ADDENDUM NO. 1

September 2, 2011

Duluth International Airport
New Passenger Terminal
Bid Package 2B
Duluth, MN 55811

SHEET TITLE
**PLAN DETAILS
EXIT CORRIDOR**

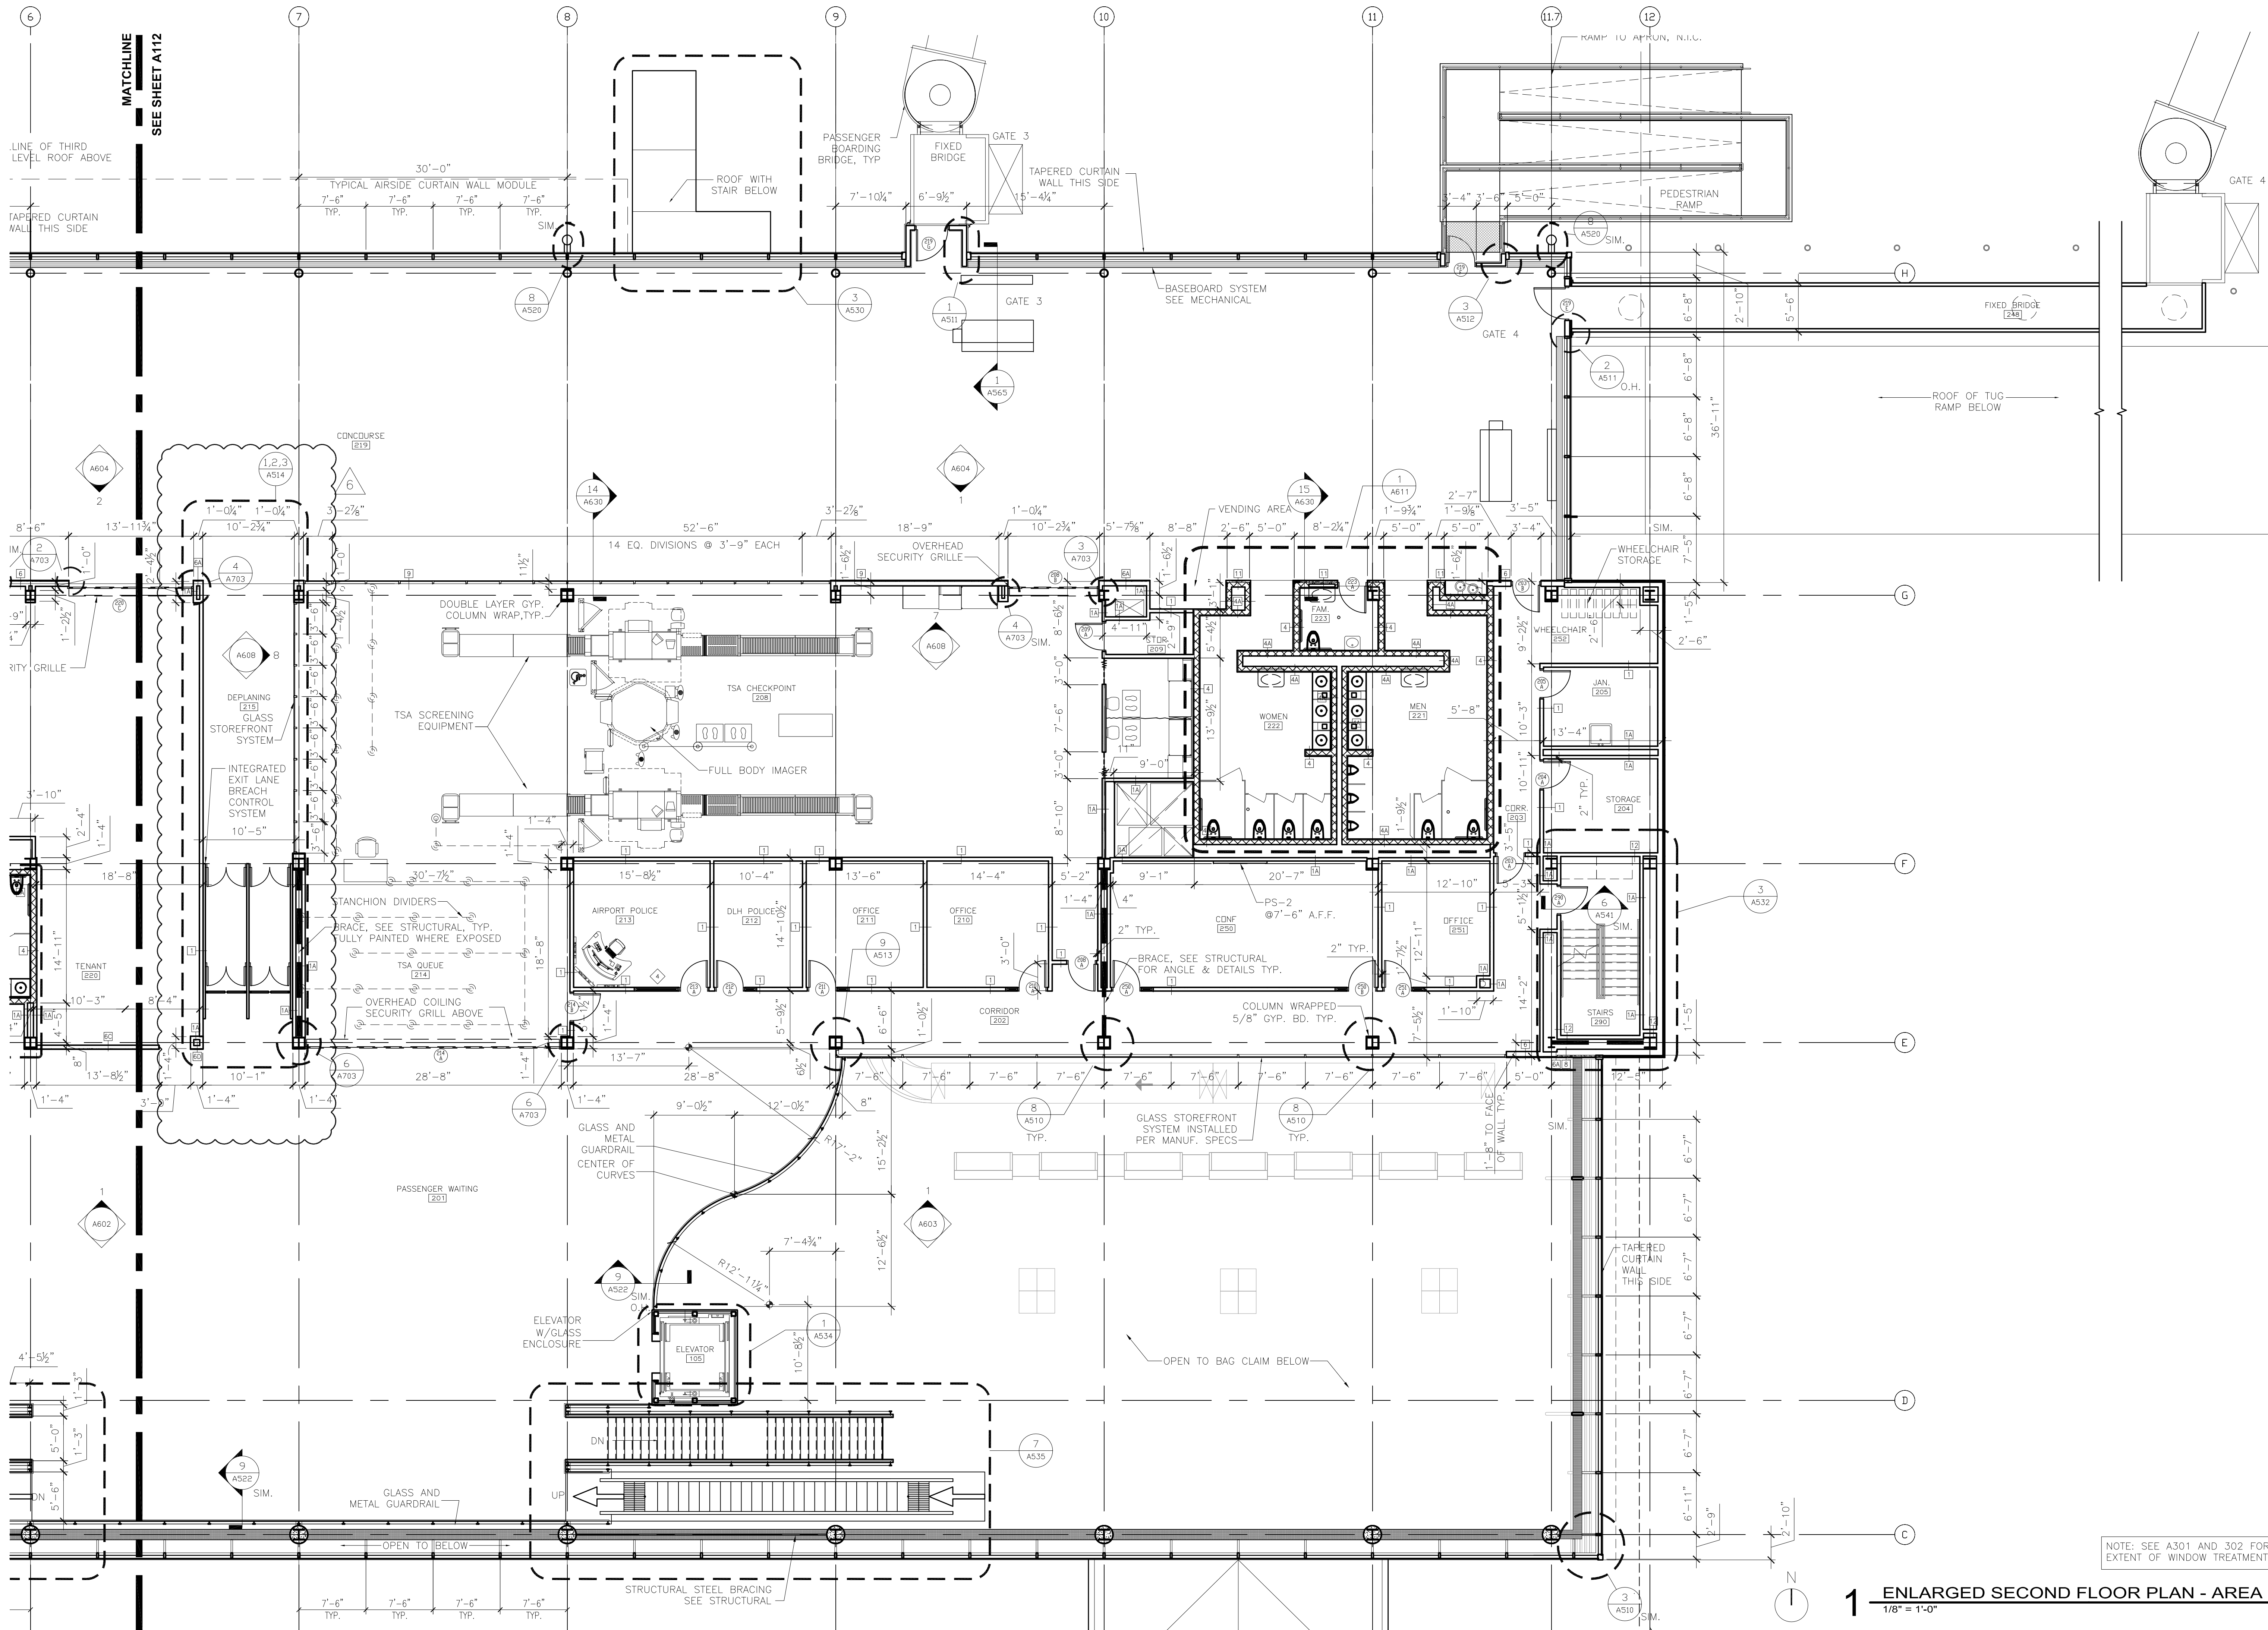
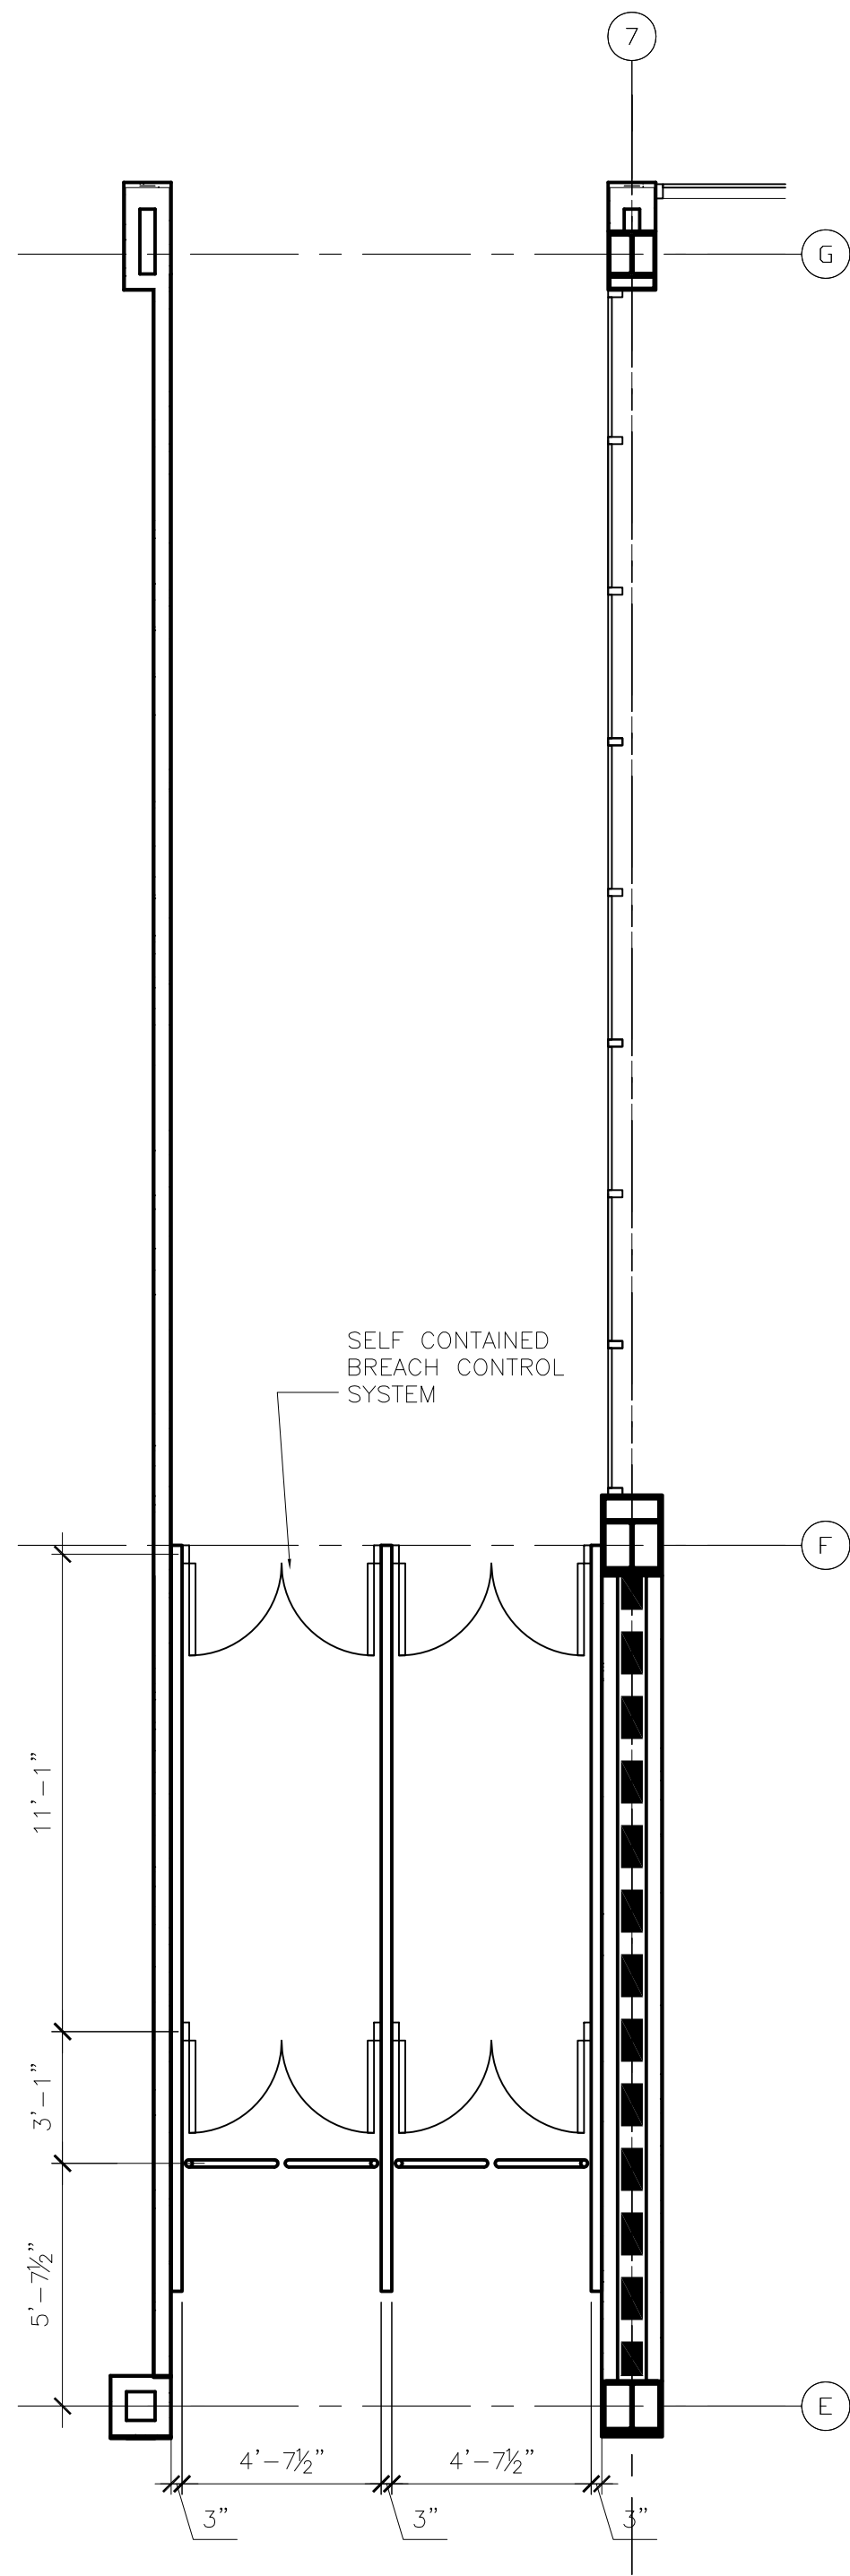
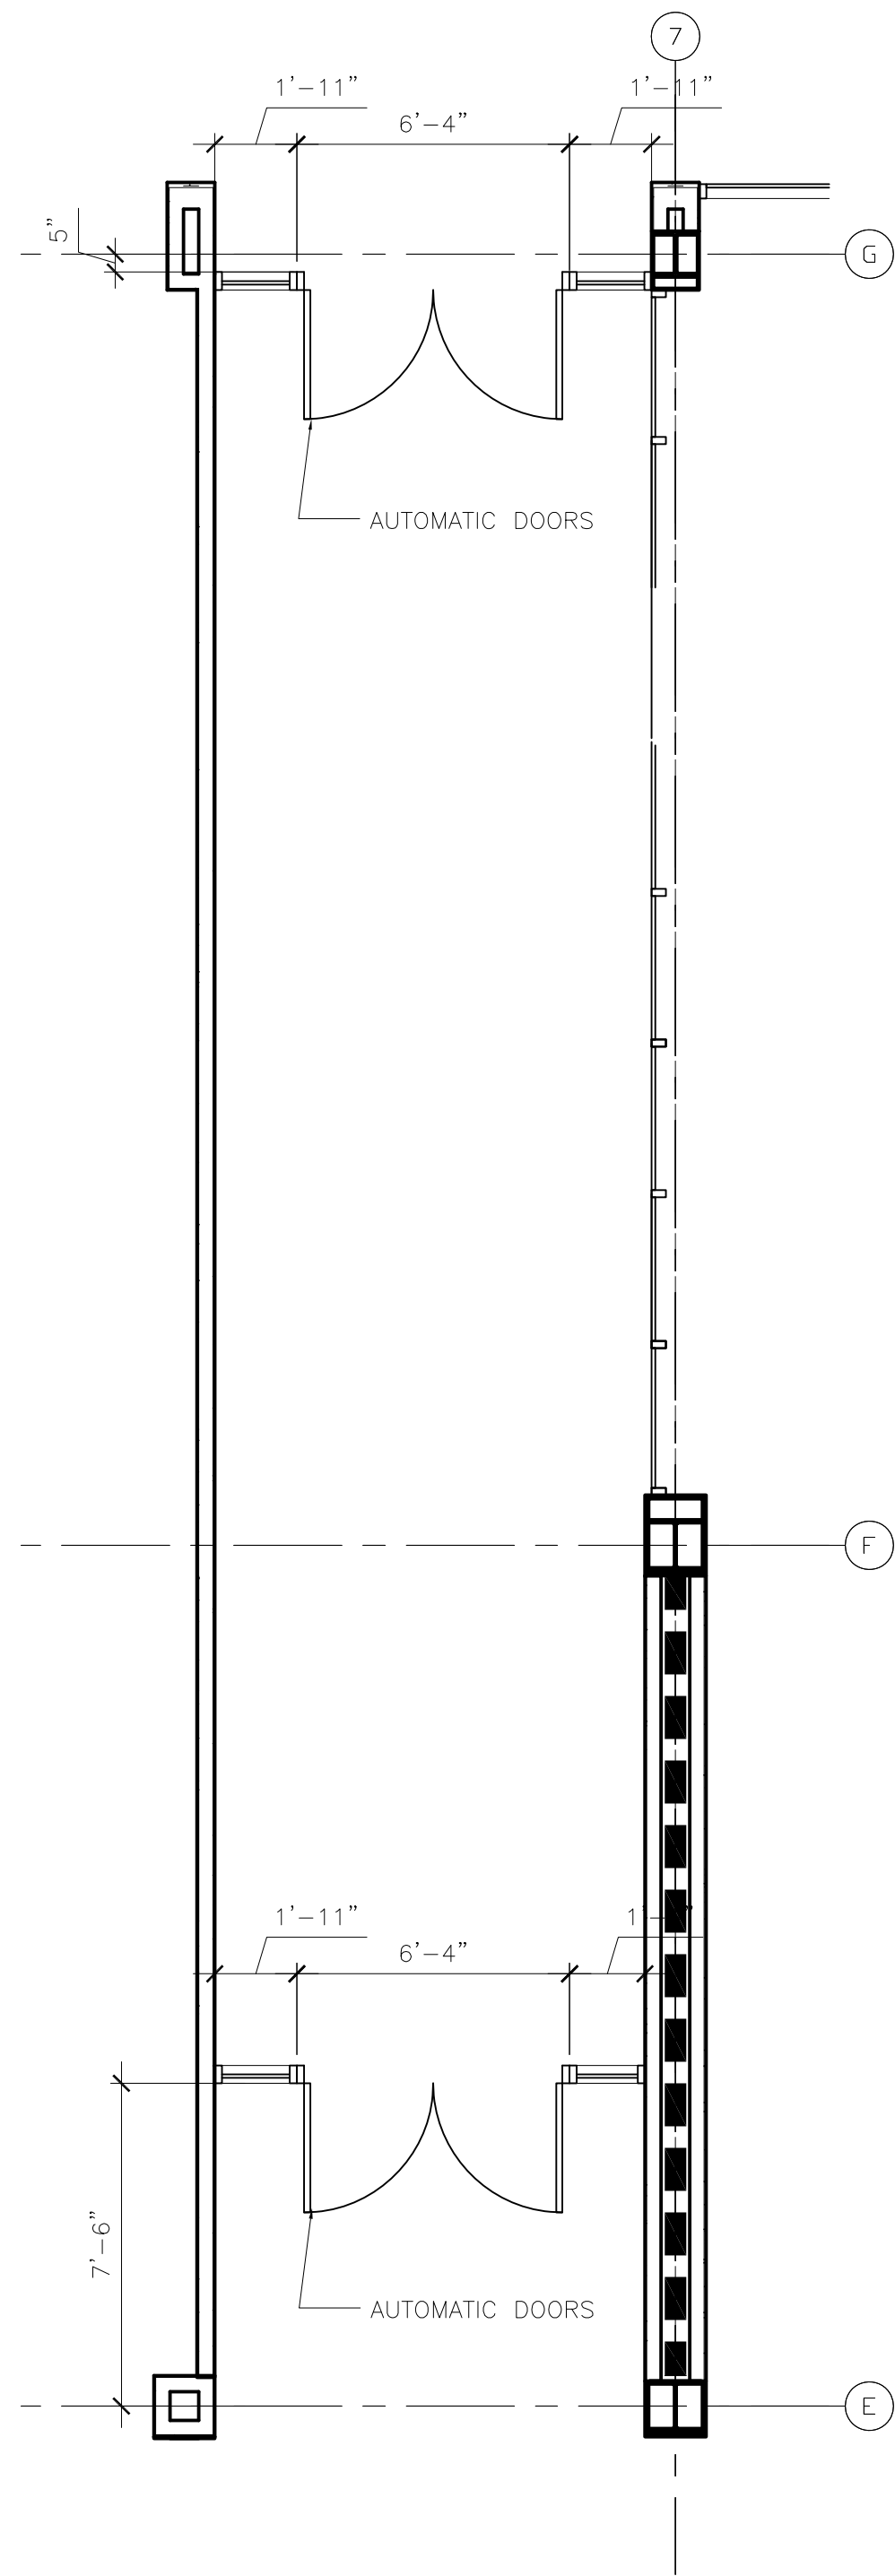
Sheet A514: Plan Details Exit Corridor

- J. **Alternate No. 7A:** Provide Integrated Exit Lane Breach Control System Alternate 7A, consisting of Self-Contained Breach Control System units as depicted on Drawing A514 and described in specification Section 13755 as part of Work Scope 13.23B.

- K. **Alternate No. 7B:** Provide Integrated Exit Lane Breach Control System Alternate 7B, consisting of motion detection systems combined with two sets of automatic entrances as depicted on Drawing A514 and described in specification Section 13755 as part of Work Scope 13.23B.

- L. **Alternate No. 7C:** Provide Integrated Exit Lane Breach Control System Alternate 7C, consisting of motion detecting optical turnstiles combined with one automatic entrance as depicted on Drawing A514 and described in specification Section 13755 as part of Work Scope 13.23B.

**ENLARGED
SECOND FLOOR
PLAN AREA B**

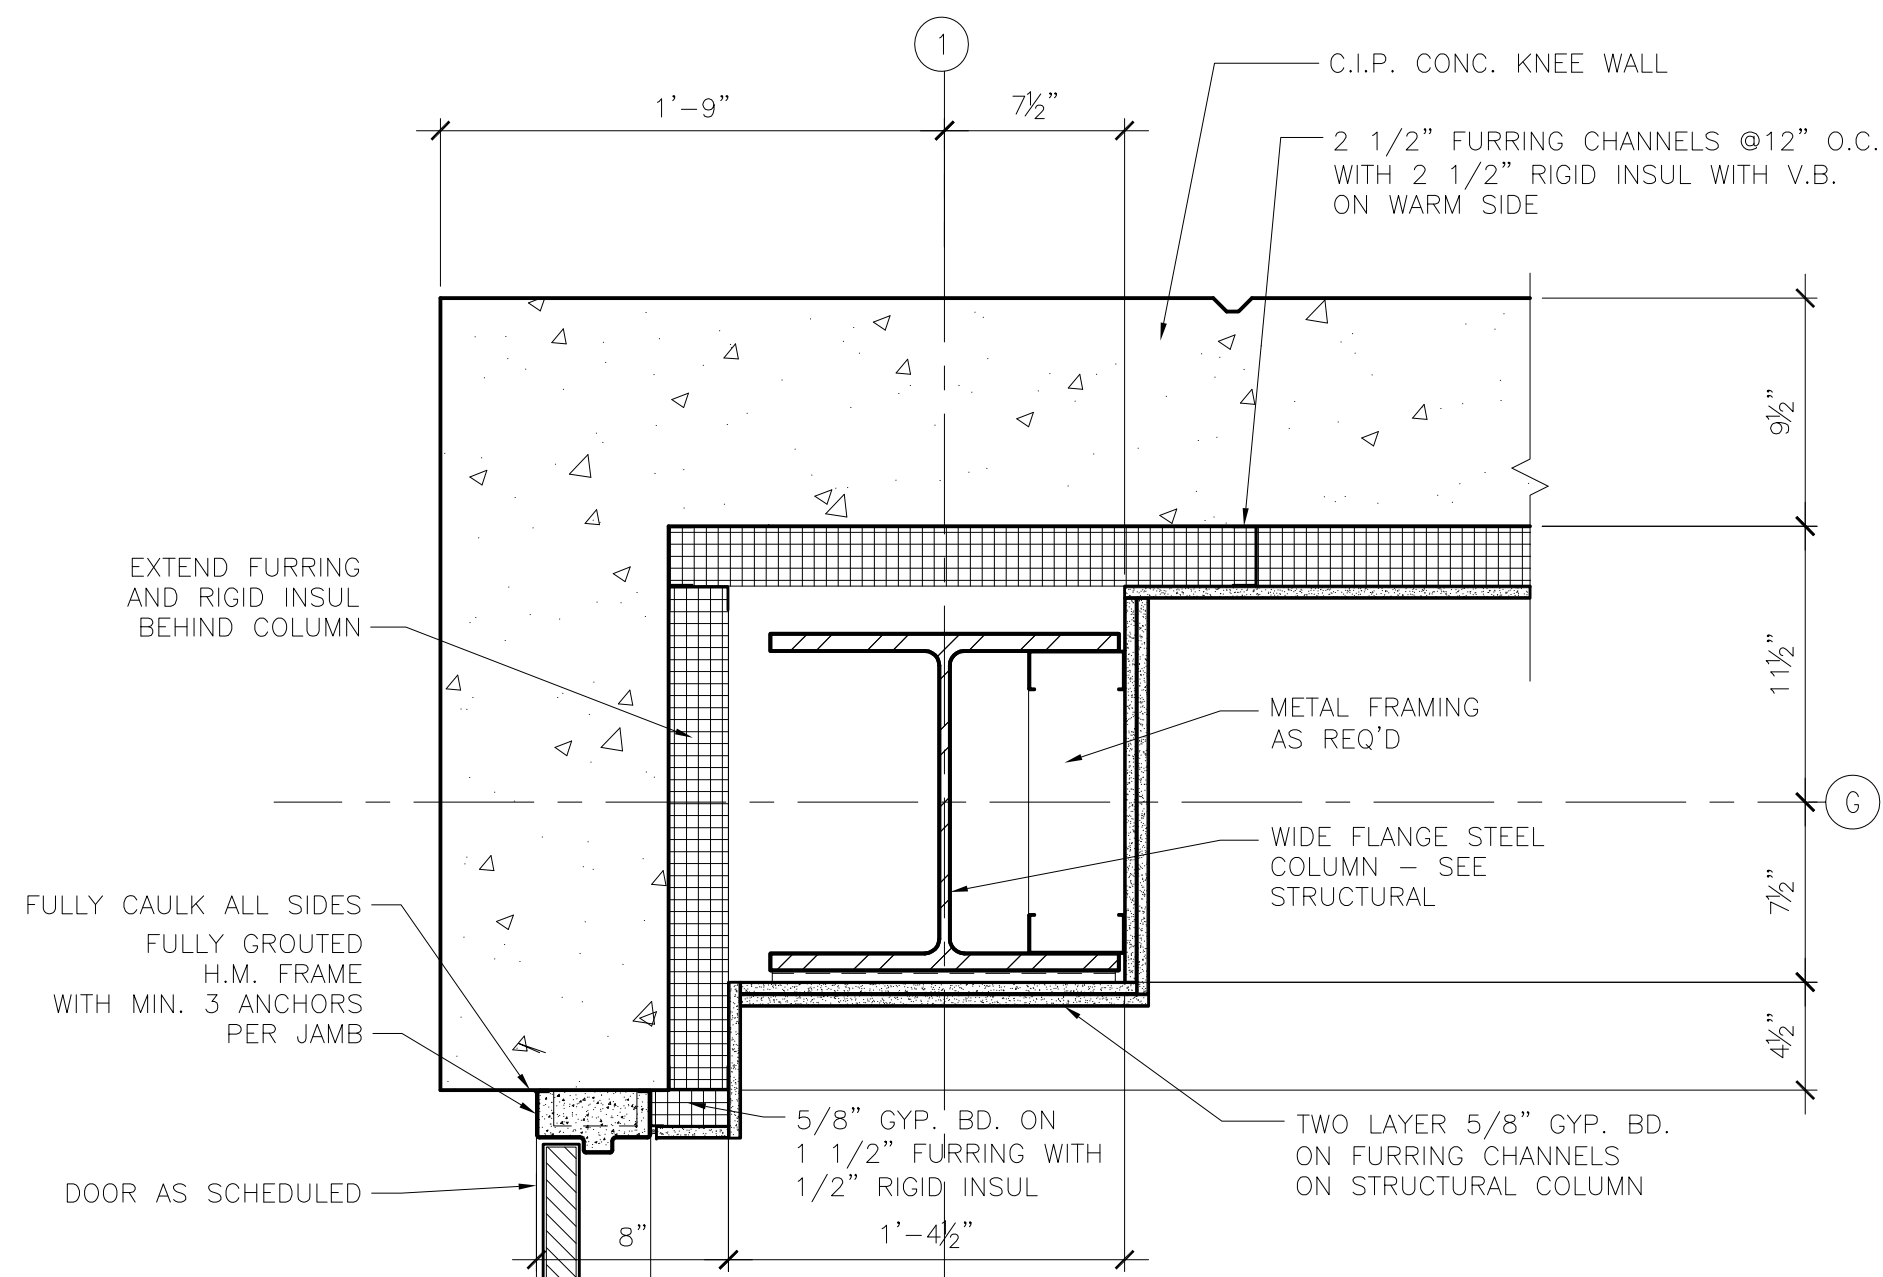
Sheet A113: Enlarged Second Floor Plan Area B: Revised Deplaning Corridor.
